CITY OF CROSSLAKE PLANNING COMMISSION/BOARD OF ADJUSTMENT

PUBLIC HEARING NOTICE

Site Location: 12292 Manhattan Pt Blvd, Crosslake, MN 56442 on Big Trout - GD

Variance for:

CERTIFICATE OF SURVEY

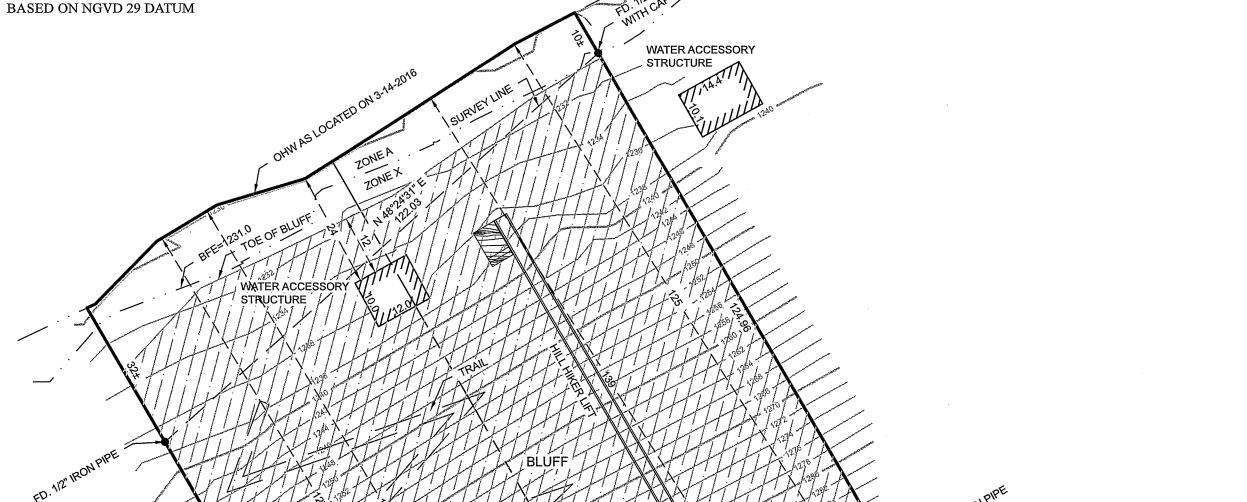
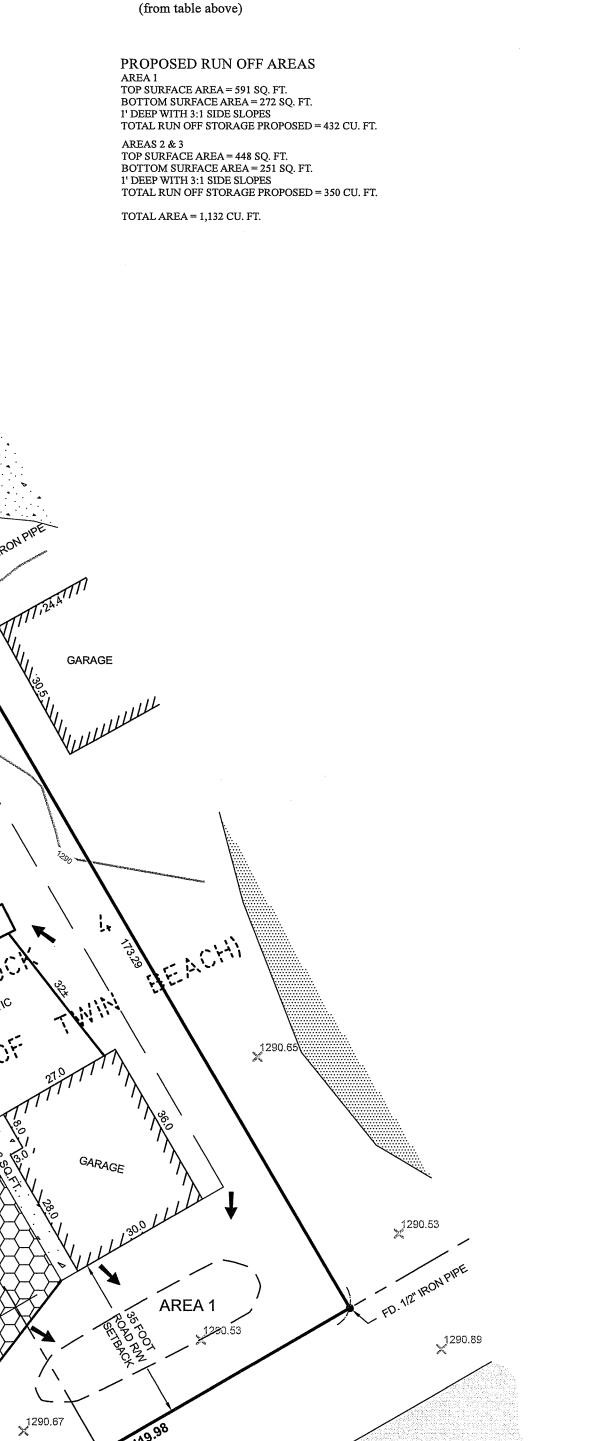
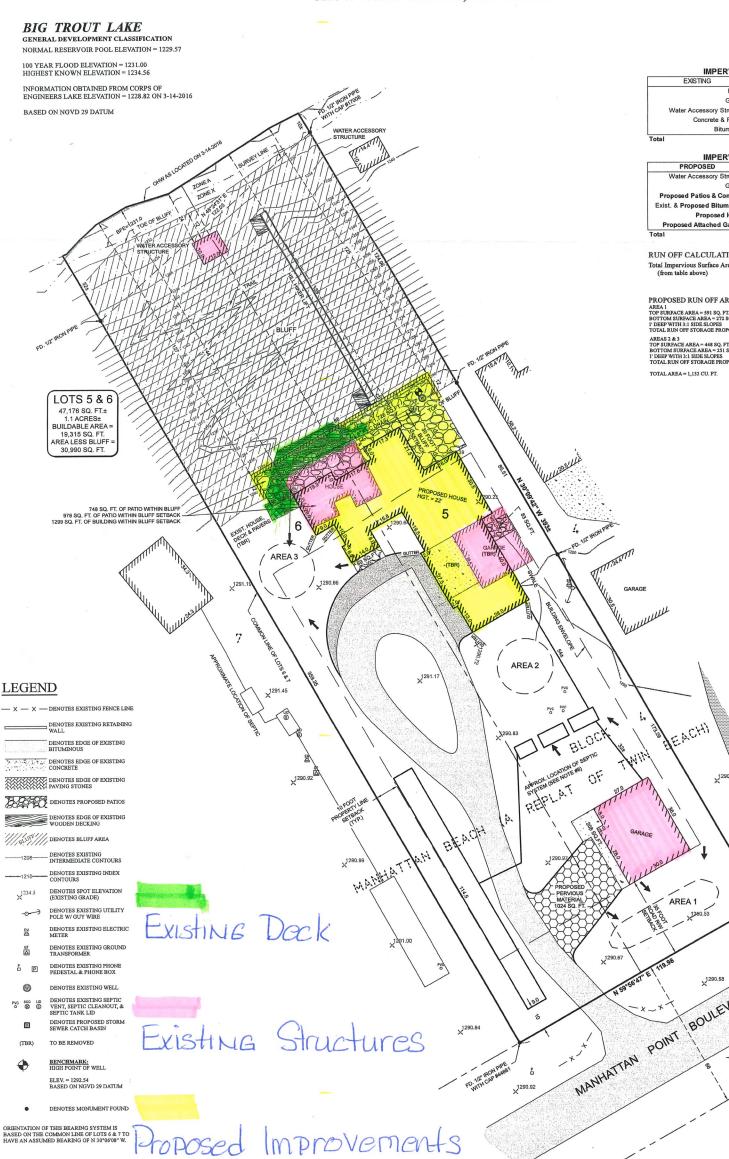
The COS shows a significant existing bluff within the northern 1/3 of the property. The requests represent severe deviations to the Ordinance standard of 30 feet from the top of a bluff of mostly new construction. Physically, development that encroaches on bluff tops can accelerate soil erosion, loading, and slope failure. Aesthetically, development that encroaches on bluff tops can compromise or eliminate the natural appearance of this topographic feature in shoreland areas. Therefore, they are important areas to avoid new or expansion of existing infrastructure where feasible and practicable.

As this is a new construction (i.e., scrape and re-build) project on 2 parcels of record with substantial buildable area (likely more than 18,000 sq. ft), there appears to available buildable area on the parcels for the entire project to move backwards, away from the bluff impact zones. The rear lot area is topographically flat, with the septic tanks being located apx. 54 feet from the proposed rear of the attached garage. Therefore, with a re-design of the parking areas and stormwater management plan, the projects could be moved perhaps up to 40 feet to the rear of the lot to still meet minimum septic tank setbacks (10 feet) and drainfield setbacks (20 feet).

The DNR strongly suggests a revised alternative to this proposal in order to better comply with the variance acceptance criteria parts 26-225 (3) a, c, and d of the Crosslake Land Use Ordinance – and therefore does not recommend approval of the current proposal.
